# **PETER W. STOTT CENTER RENOVATION**

# **VIKING PAVILION**

**Land Use Review Hearing**

**March 3, 2016**

## East Terrace

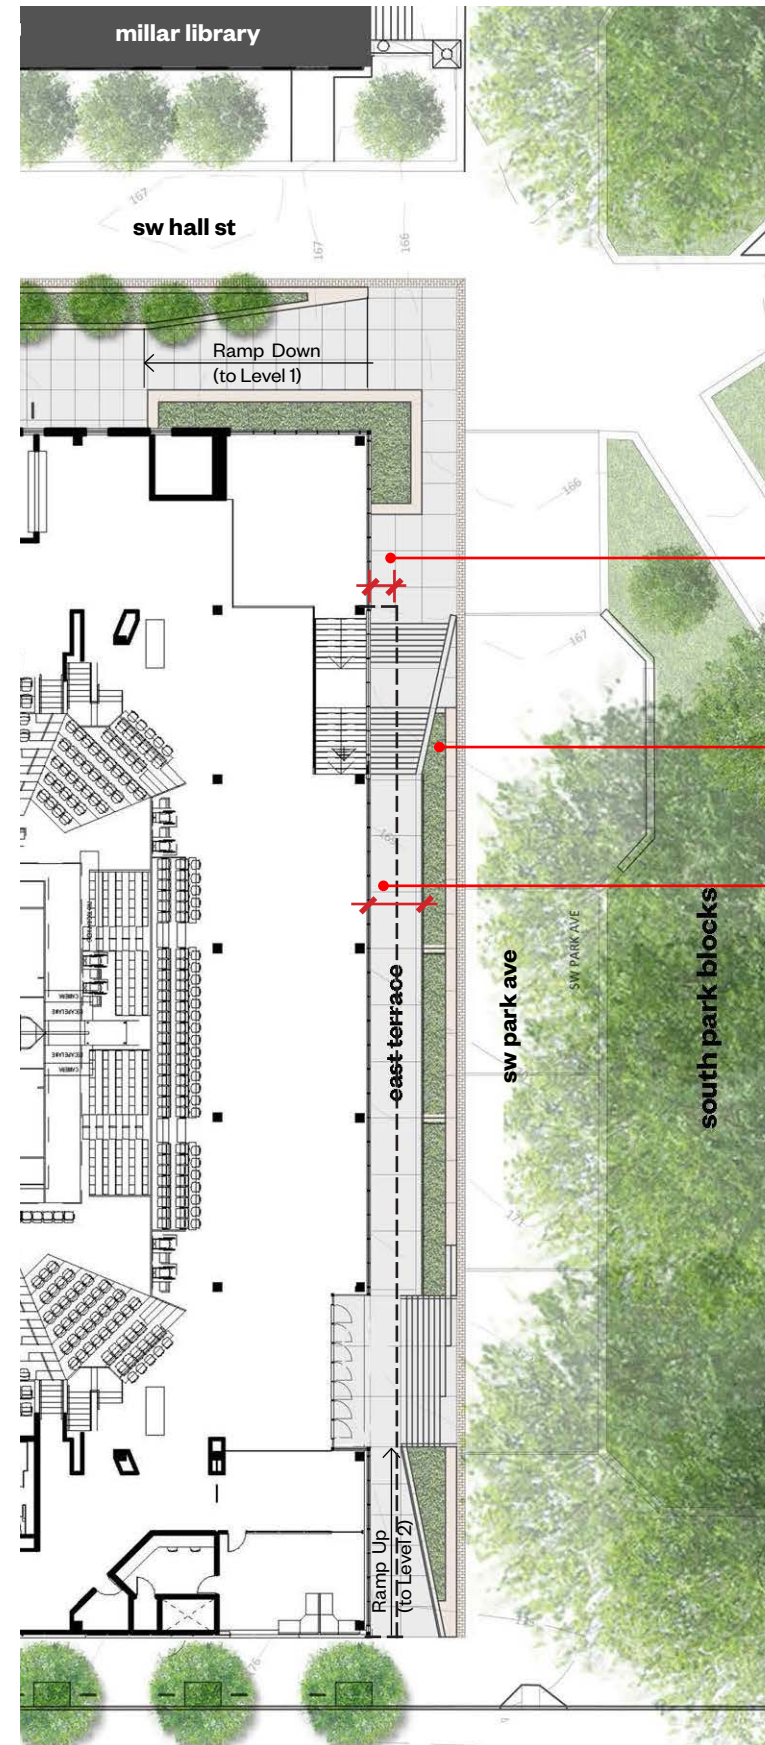
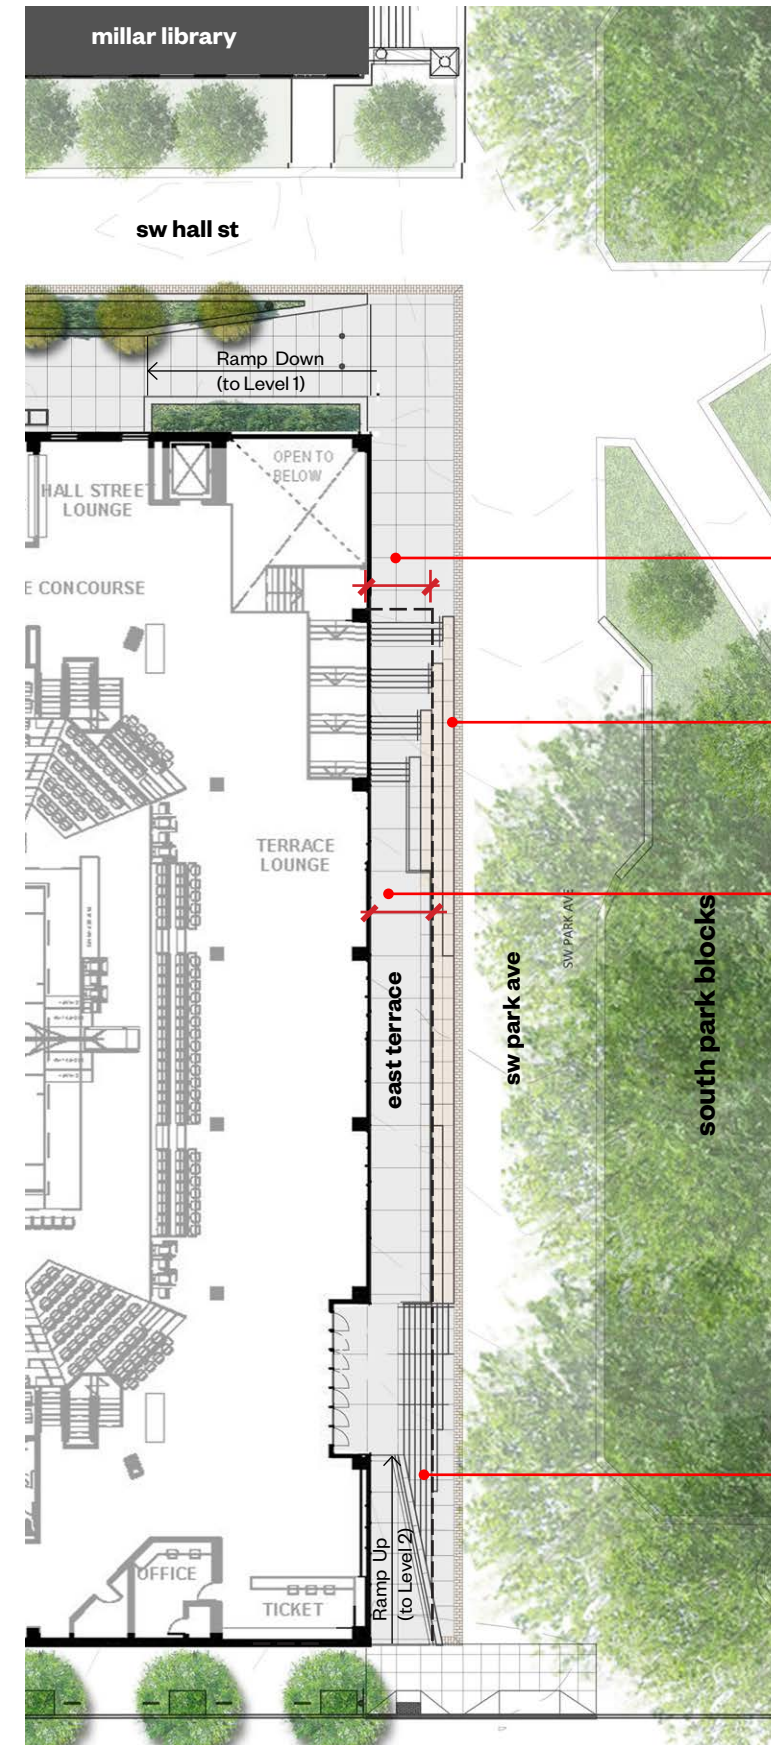
- The depth of the east terrace has been increased from 8'-6" to 10'-0".
- The terrace canopy has been extended from 4'-6" to 10'-0" to cover the entire terrace, providing a sheltered space overlooking the Park.
- The north end of the terrace has been refined to be a cascading edge that steps down in four equal increments to meet the Park. This reduces the perceived height of the terrace for pedestrians walking by on SW Park Ave and provides a series of seating areas facing the Park.
- The landscaping has been removed from the front of the terrace and all vertical faces of the terrace/seat walls are faced in the same blend of tan bricks used at the base of the building, further unifying the pedestrian experience of the buildings perimeter.

enlarged plan

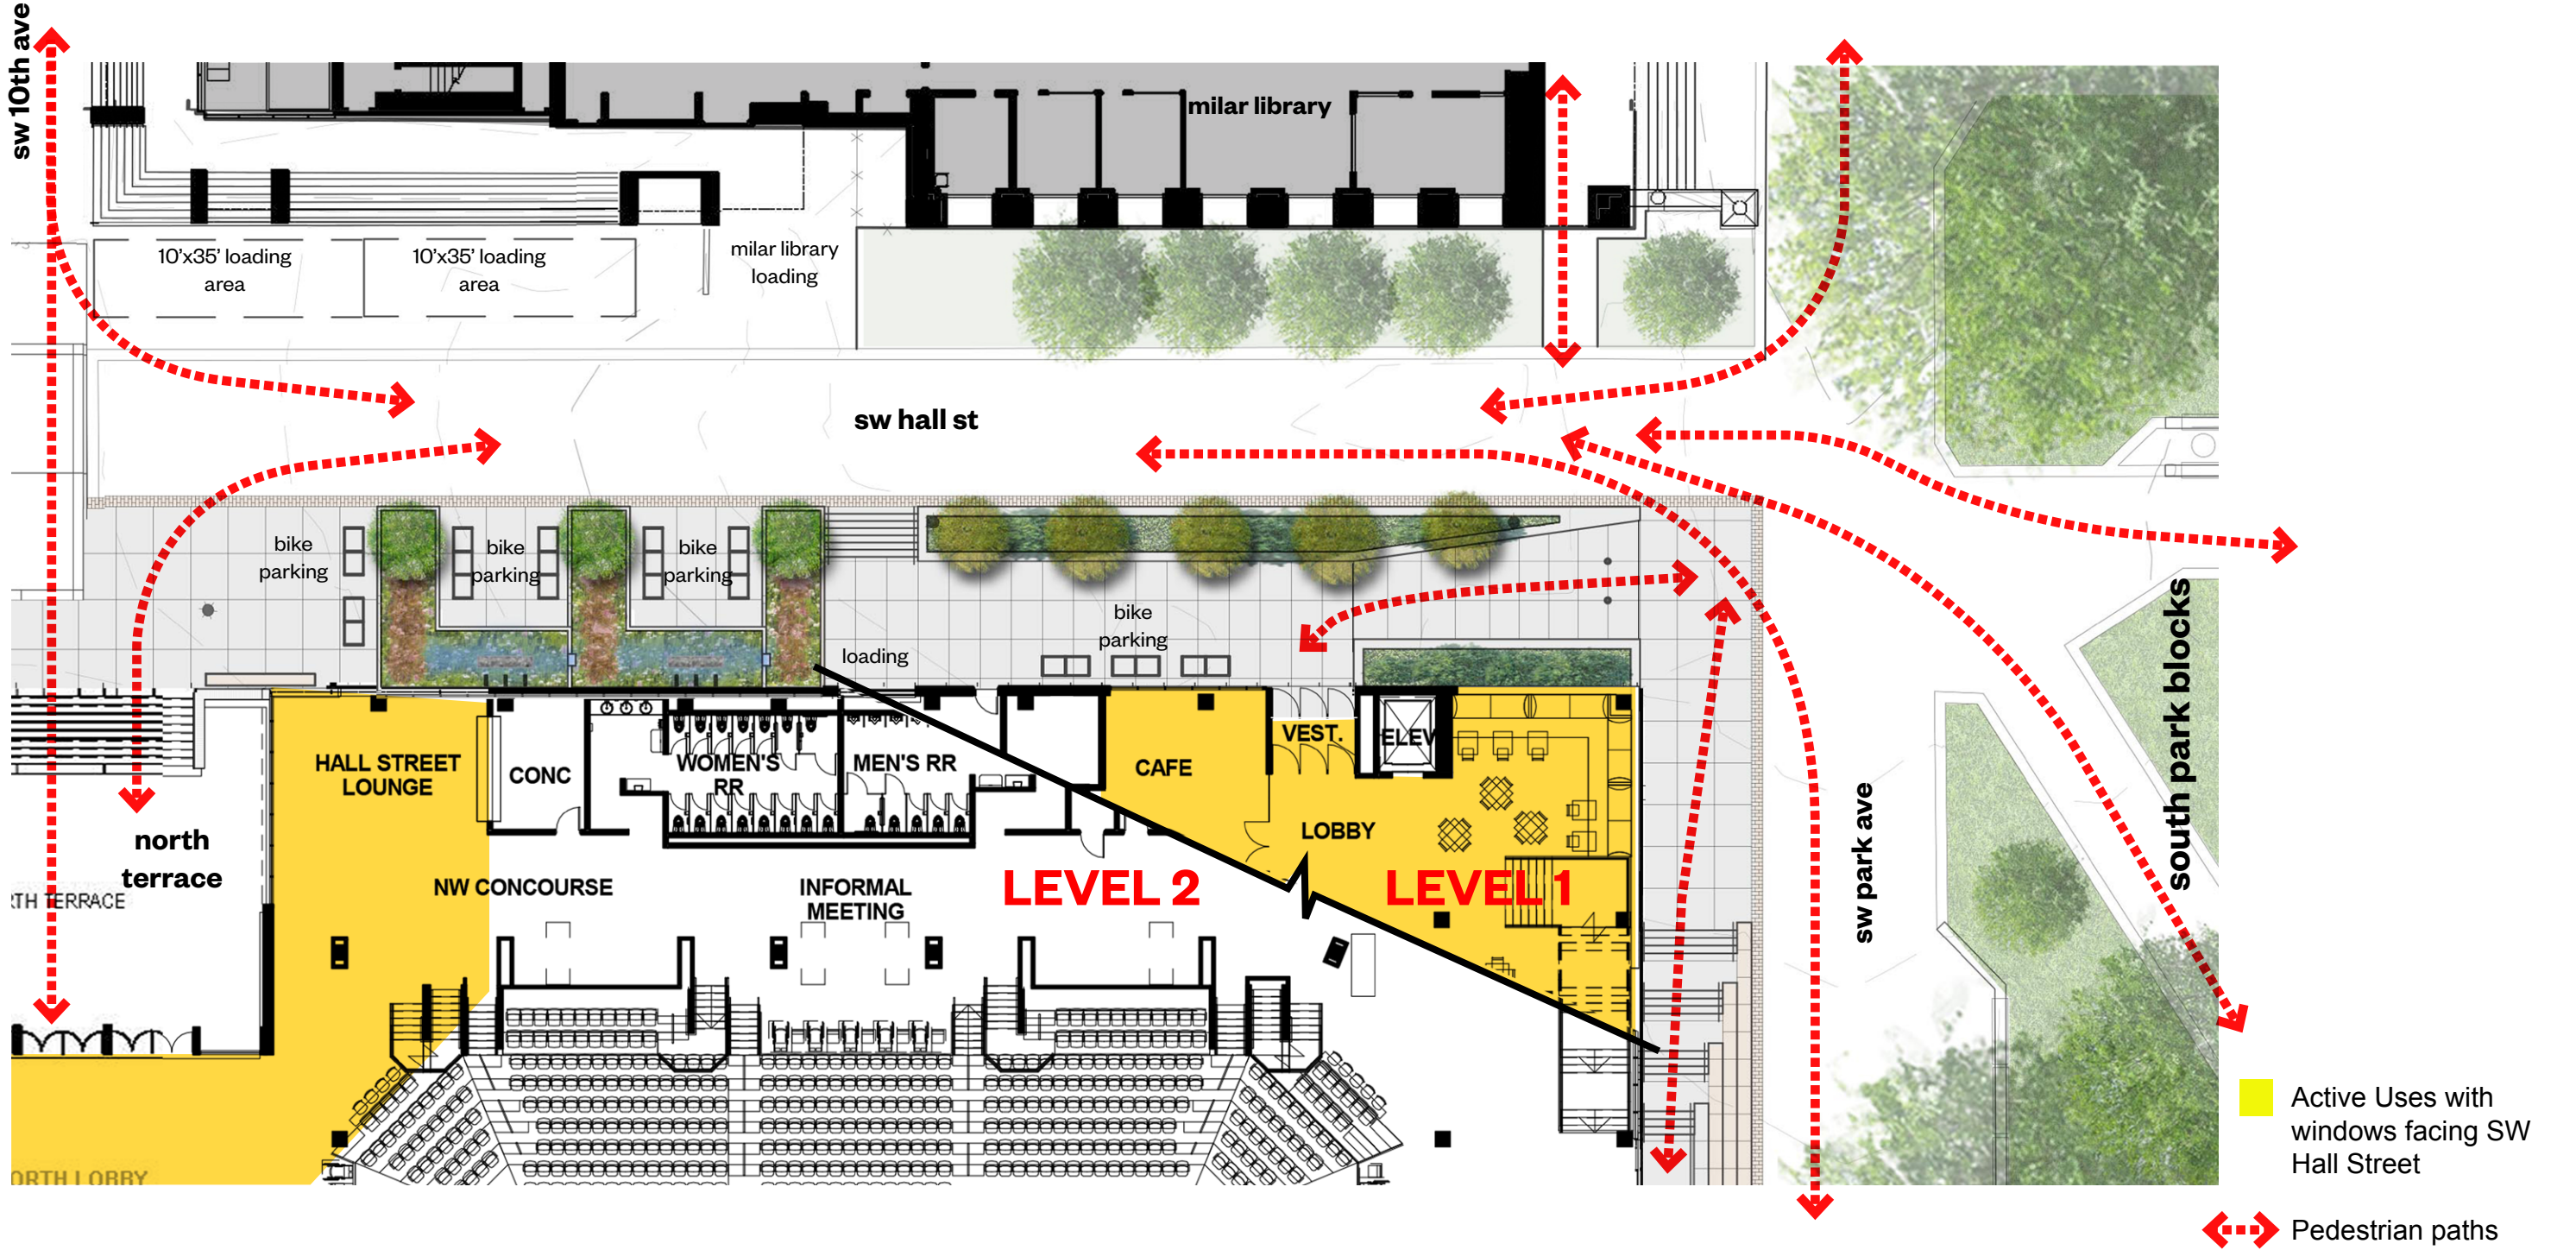
• To animate and activate the edge of SW Hall Street outside the building, a series of bike parking clusters contained by cascading stormwater planters has been created. These

planters will treat all the roof water from the arena roof, fed by ornamental scuppers that emerge from the brick base of the building. By consolidating and celebrating these

uses, this area helps demonstrate PSU's commitment to sustainability and alternative transport and creates an intermediary scale between people and the building.

• Plants have been chosen for shape, seasonal color, appropriateness for stormwater planters, hardiness, ease of maintenance and shade tolerance. Refer also to C.22 .

east – DAR

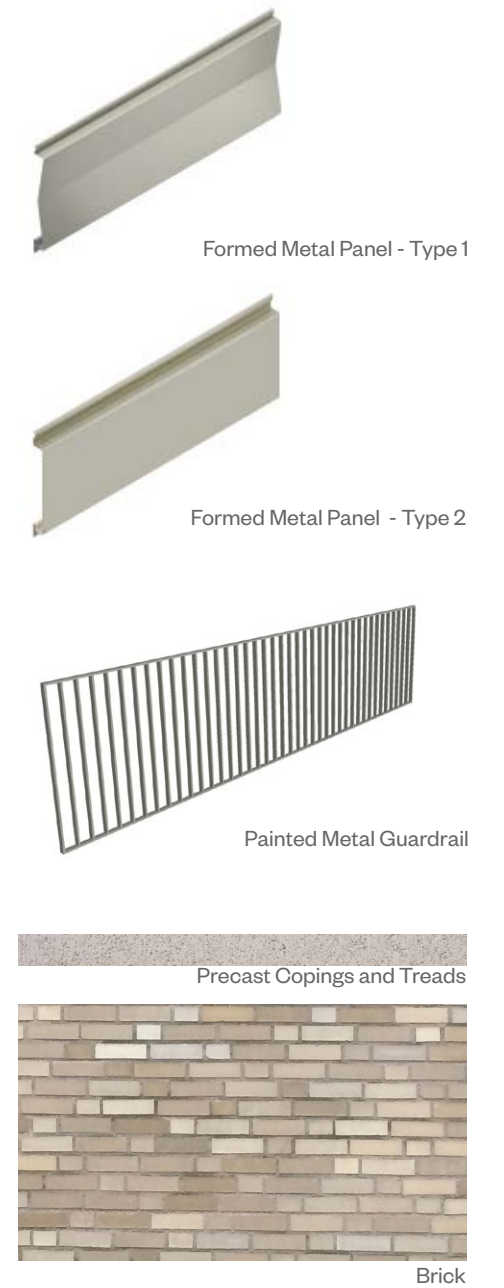
- The size of the proposed sign over the main entry facing SW Park has been reduced to be less than 100 square feet.

- On the east, the proportion of glazing centered in the façade and above the canopy has been increased to double the width of the previous window openings.

- Solar studies and energy modelling confirmed that areas of solid wall system above the canopy overhang on the east façade reduces the cooling loads significantly while also mitigating the impact of direct sunlight and glare on interior uses.

- On the east, the proportion of glazing centered in the façade and above the canopy has been increased to double the width of the previous window openings.
- The color of the metal proposed has been revised from gray/silver to a more tan “champagne gold”. This relates more directly

- All metal panels proposed will be of heavy gauge (18 gauge unbacked, 20 gauge corrugated/pleated profiles) with concealed fasteners.
- The metal panels proposed are all located in areas that are not within reach of pedestrians: glass, brick, and concrete are

- Curtainwall snapcap extensions are provided at vertical mullions in glazed areas between metal panels on the east to provide further articulation, depth and more sun control to this façade as the proportion of glazing in this area
